**CITY OF ISANTI
PLANNING COMMISSION MEETING
TUESDAY, March 16, 2021
Immediately following the 7:00 pm City Council Meeting
CITY HALL**

SUBJECT: Site Plan Review and Conditional Use Permit for a Caribou Coffee with a drive-thru located at 260 5th Ave NE

Date: February 23, 2021
To: Sheila Sellman, Community Development Director
From: Jason W. Cook, P.E.
City Engineer
Subject: Caribou Cabin Isanti - Plan Set - Engineering Review
City of Isanti, MN
Project No.: 0R1.123130

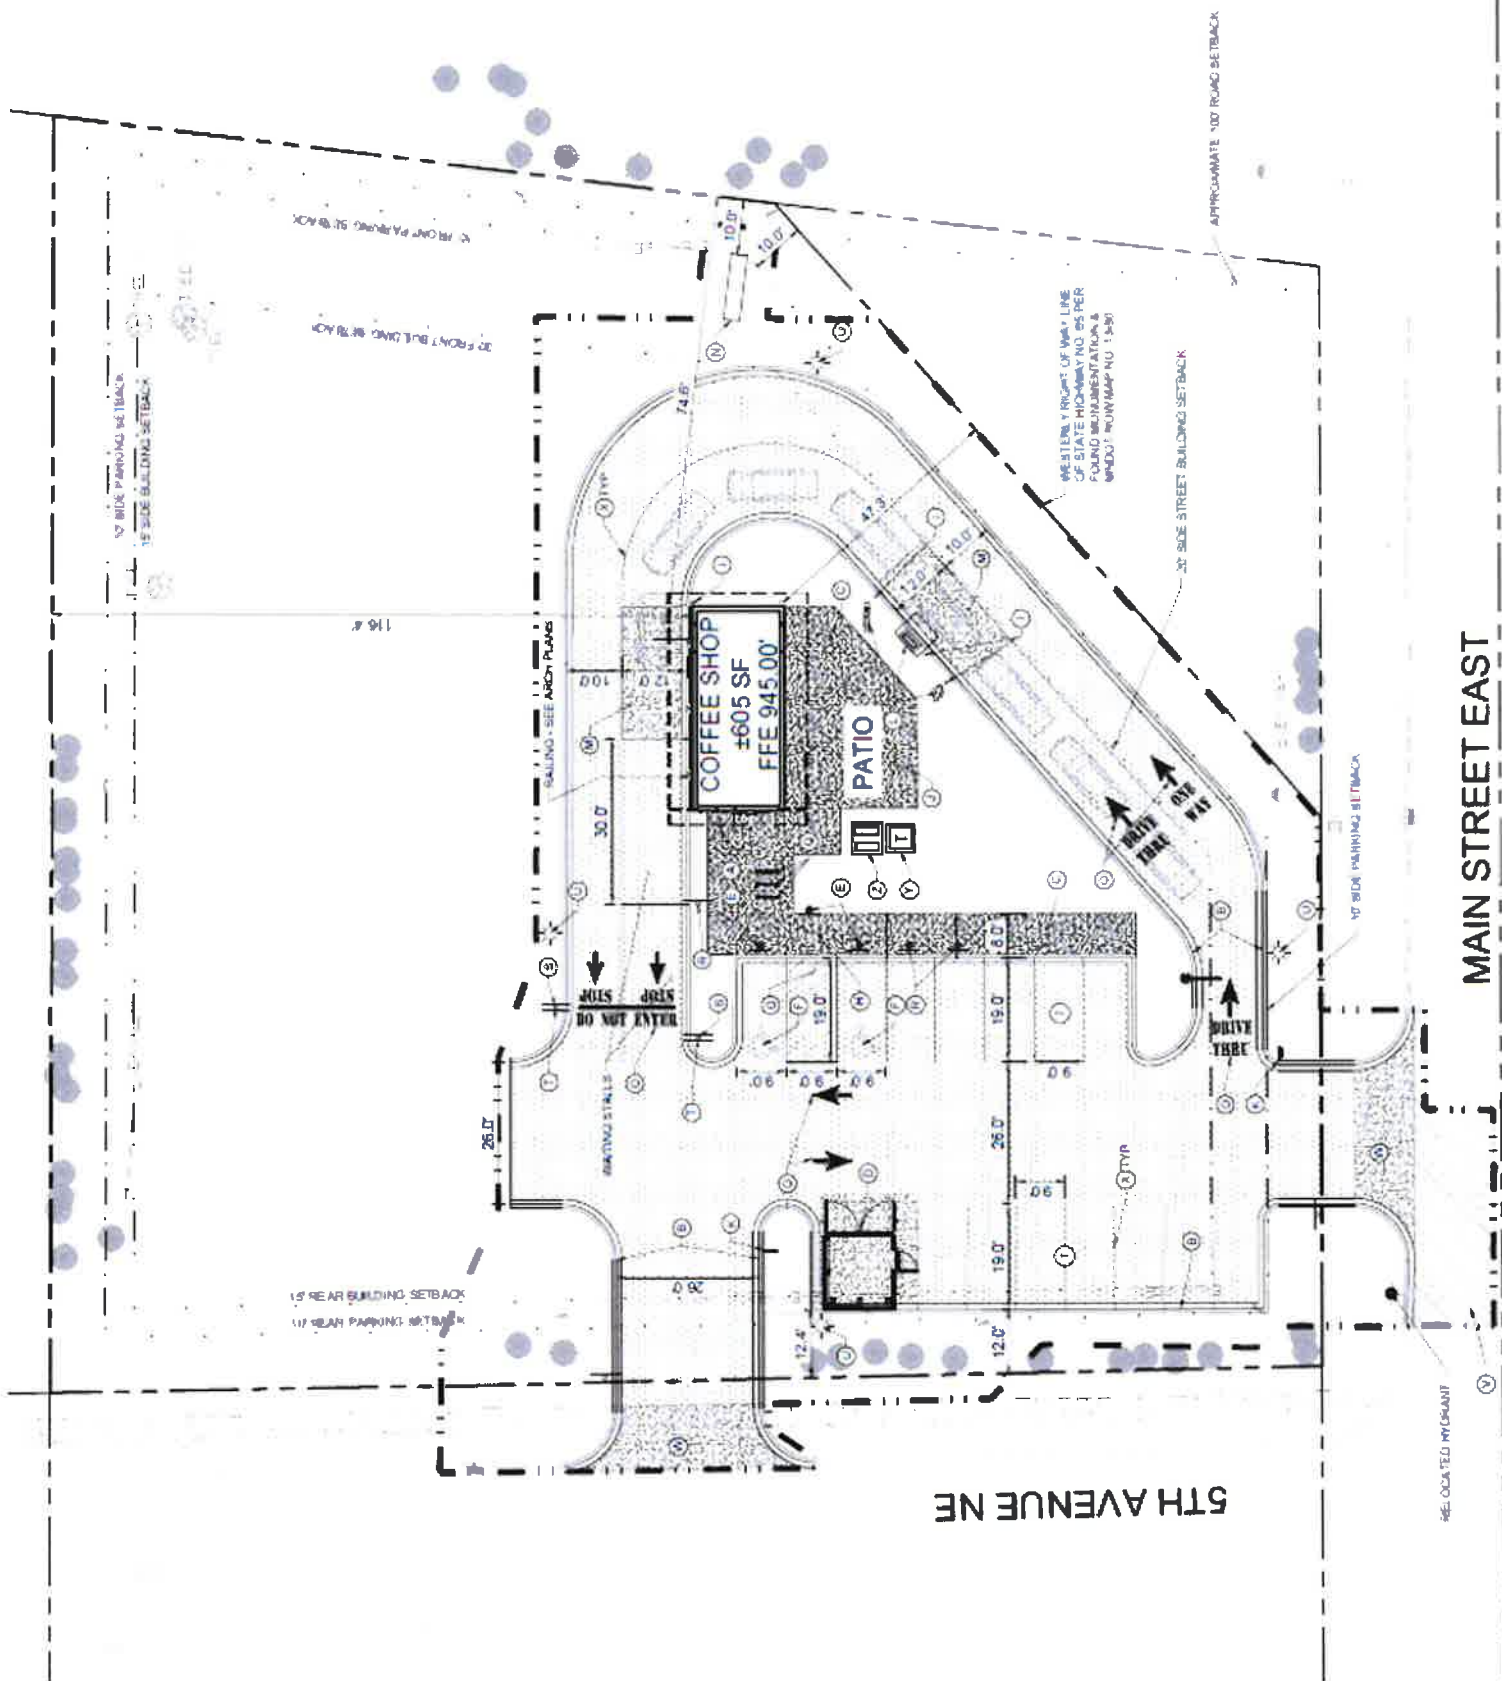
The area of the parcel is 44,902 square feet or roughly 1.03 acres in size. The proposed building is 605 square feet and will not meet the minimum building size requirement (15% of lot size) in the Highway 65 Overlay District. The area of the proposed building will be 1.3% of the total lot size. However, there will potentially be two buildings on this site, being flexible now will allow this to happen.

The proposed development will be roughly 0.57 acres on the south end of the site and the remaining 0.46 acres is intended to be developed in the future. The landscaping requirement of 25% of the total lot area as green space will be met for this phase of development.

The site features 90-degree parking stalls and will follow the required stall dimensions of 9 feet in width and 19 feet in length. The drive aisle widths are proposed at 26 feet and meet the requirement for two-way vehicle circulation. The entrance to the drive-thru lane is proposed at roughly 10 feet in width, MN State Fire Code states that this width shall be a minimum of 20 feet to allow fire apparatus access to the building and customer vehicles in the drive-thru. A minimum turning radius of 28 feet for access roads is also a regulation listed in the State Fire Code, and mentioned in the Fire Chief's memo. The applicant is requesting the ability to maintain the 12' width as they feel they are providing adequate access to the 605 square foot building via two other access points in an emergency situation as depicted on the site plan. The Planning Commission should discuss if they want to allow this request.

The landscaping plan proposes to include 18 trees on site with 10 overstory trees planted along the perimeter of the site and 8 ornamental trees on the interior and north perimeter. The City Landscaping Ordinance requires that the site have at least 12 trees based on the lot frontage calculation (1 tree per 50 ft of lot frontage) and the proposed amount of 18 trees will meet this standard. The tree species and plantings proposed on the landscaping plan are consistent with the City Tree List and are permitted to be planted on site. Mulch will be placed around the perimeter of the site and sod will be laid on the interior of the site in between the drive-thru lane and the outdoor patio area.

Staff Recommendation: Staff recommends approval of the Site Plan and Conditional Use Permit for the proposed Caribou Coffee free standing building located at 260 5th Ave NE with the following conditions:

1. Lighting Designs shall follow requirements in Subdivision 5 Outdoor Lighting Standards of Section 14 of Isanti's City Zoning Ordinances.
2. Outdoor Patio design/layout of tables and seating shall be shown on site plan and approved by staff and as part of the development agreement.
3. Wall signs shall be altered to be within 1 foot from the side of the building.
4. All freestanding signs require a sign permit to determine dimensions and locations and are not approved as part of this site plan review.
5. Applicant shall apply for all permits associated with the building including a building permit, mechanical permit, plumbing permit, electrical permit, and sewer and water hookup.
6. All other conditions listed in the City Engineer's memo, dated 2/23/2021 shall be met.
7. A minor development agreement shall be executed and recorded prior to issuance of a building permit.

1 NORTH ELEVATION
1/2" = 1'-0"

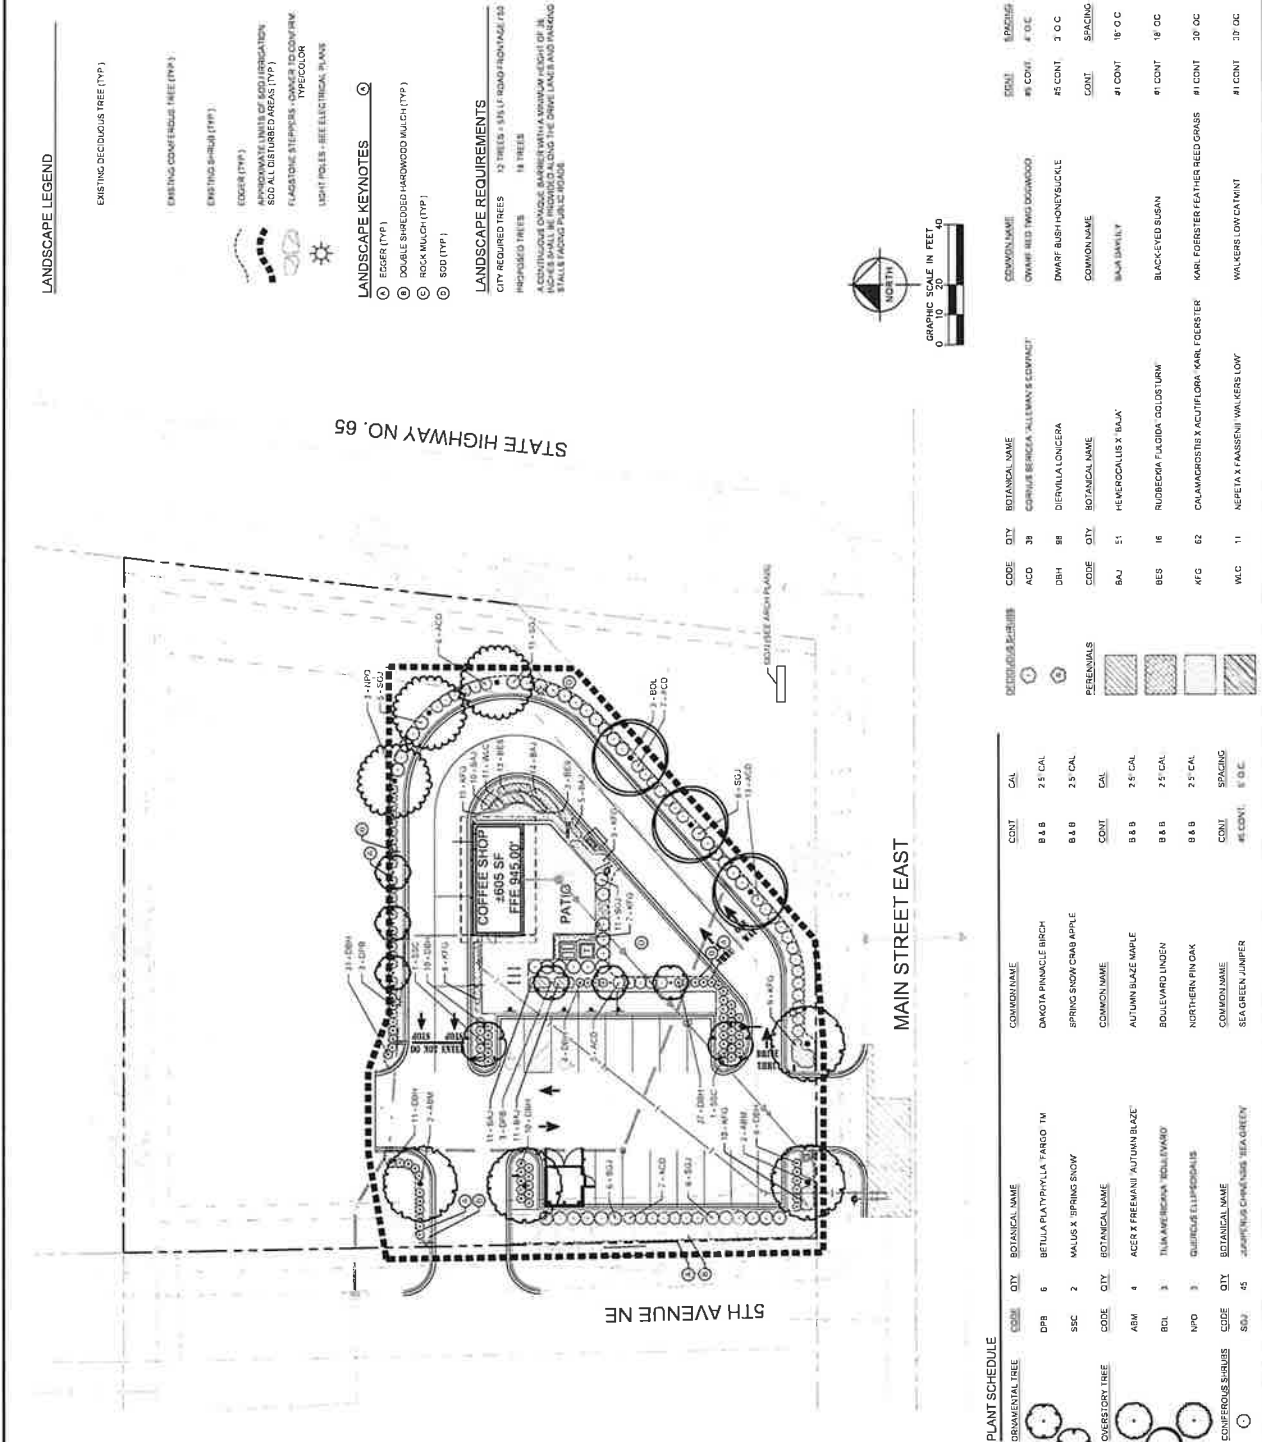
Signs located on the front and rear elevations show lettering that overlaps the side of the building and does not meet this requirement to be located a minimum of 1 foot from the side of the building. Sign plans shall be altered to meet this requirement.

Wall signs are proposed on all four sides of the building. The front and rear elevations will have similar wall size dimensions and both side elevations will have the same dimensions. Two wall signs are proposed on both sides of the building and will not meet this requirement. Planning Commission shall discuss the wall signage proposed on the building. What is your recommendation?

RECORD PLAN
ARCON CONSTRUCTION CO. INC
P.O. BOX 129
1000 1st Avenue
Isant, MN 55447
855-878-4474
DATE: MARCH 2007

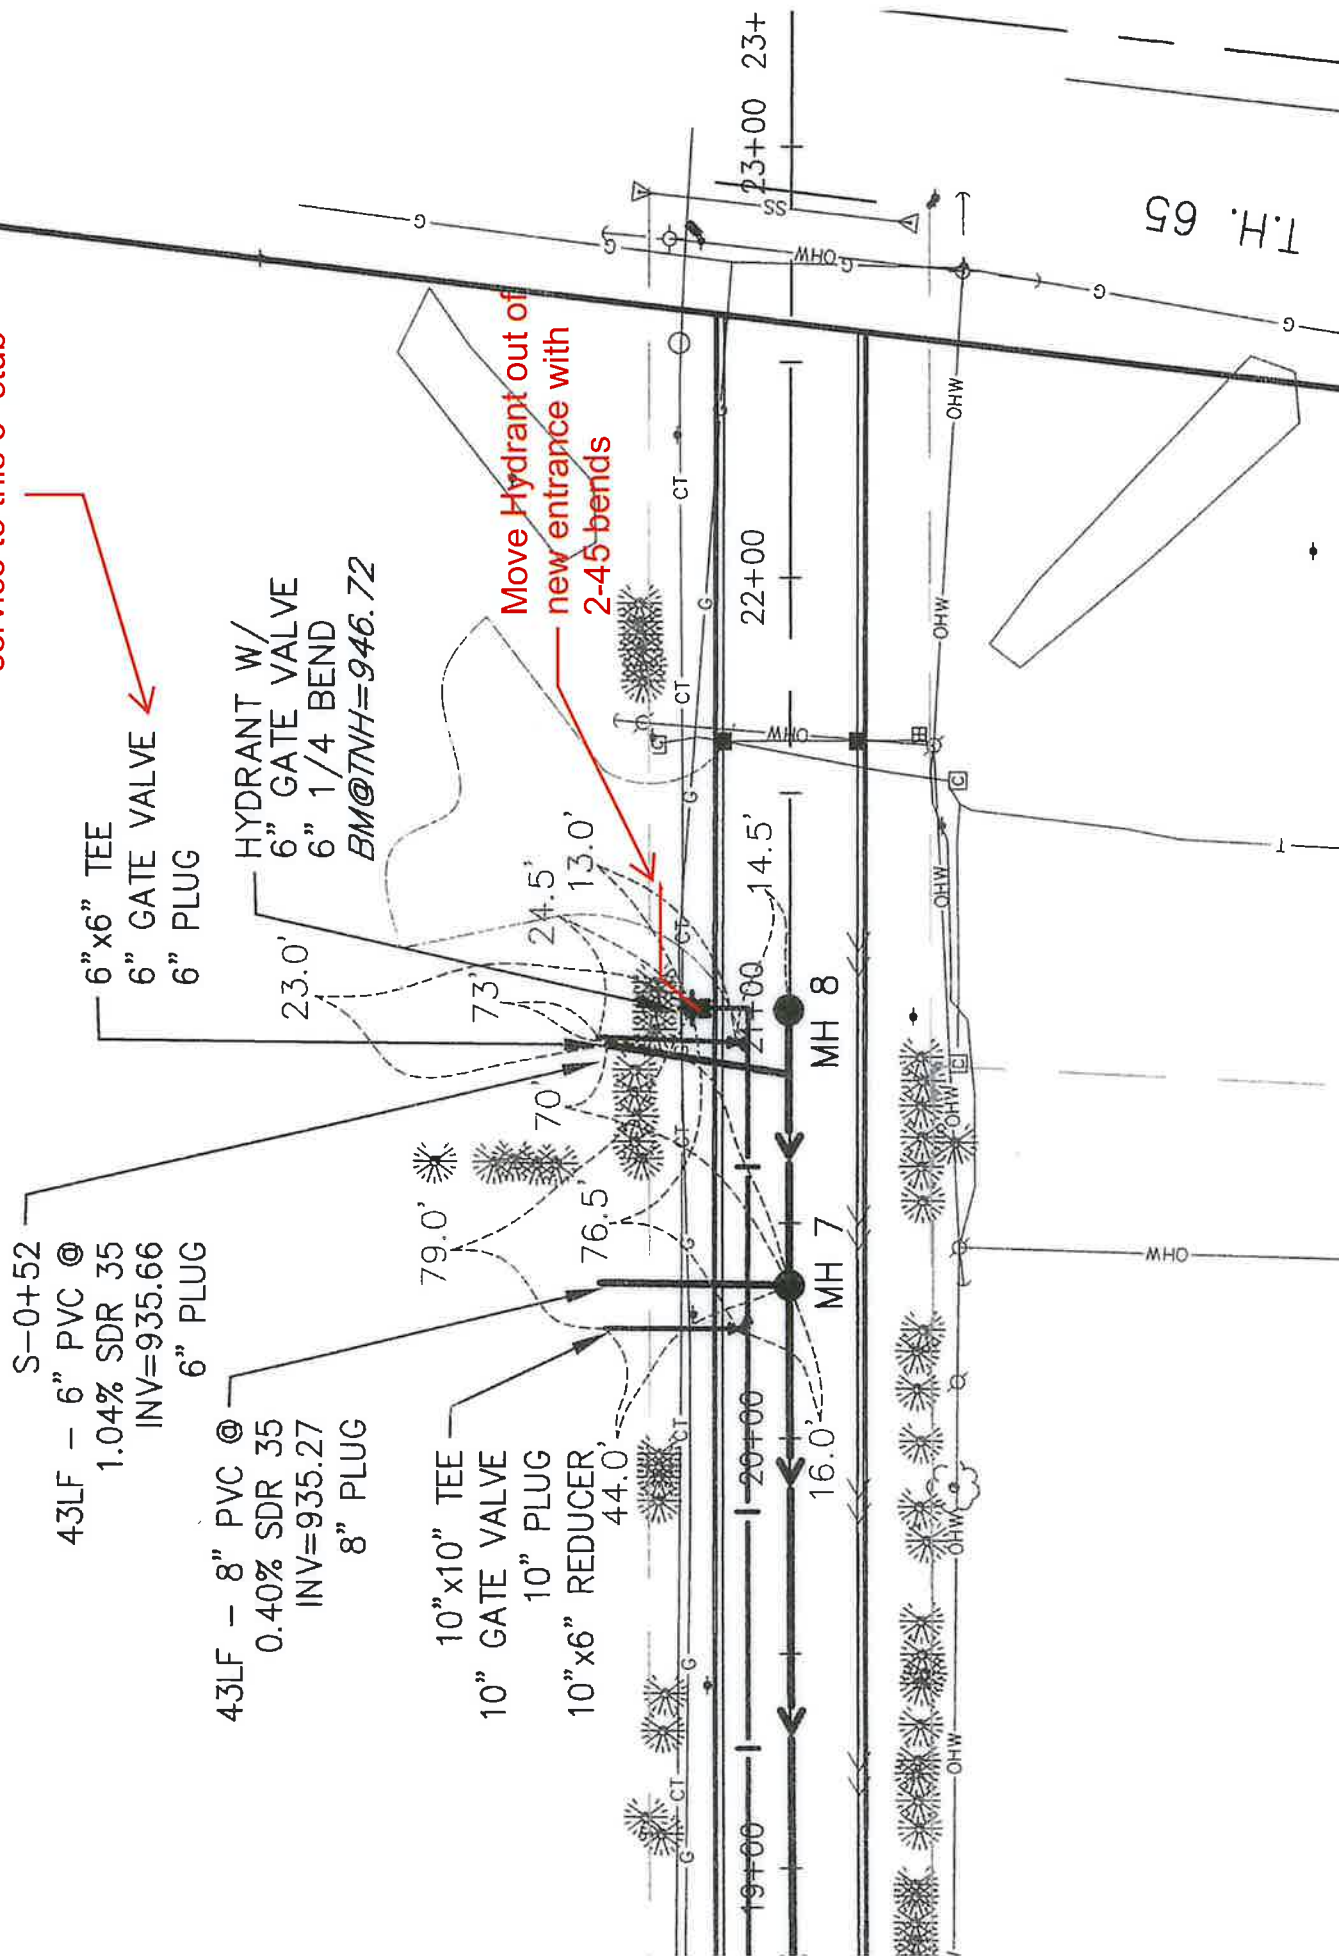
1. See attached marked up record drawing for location of existing water service stub and alternate hydrant relocation. Remove street patch area from plans.
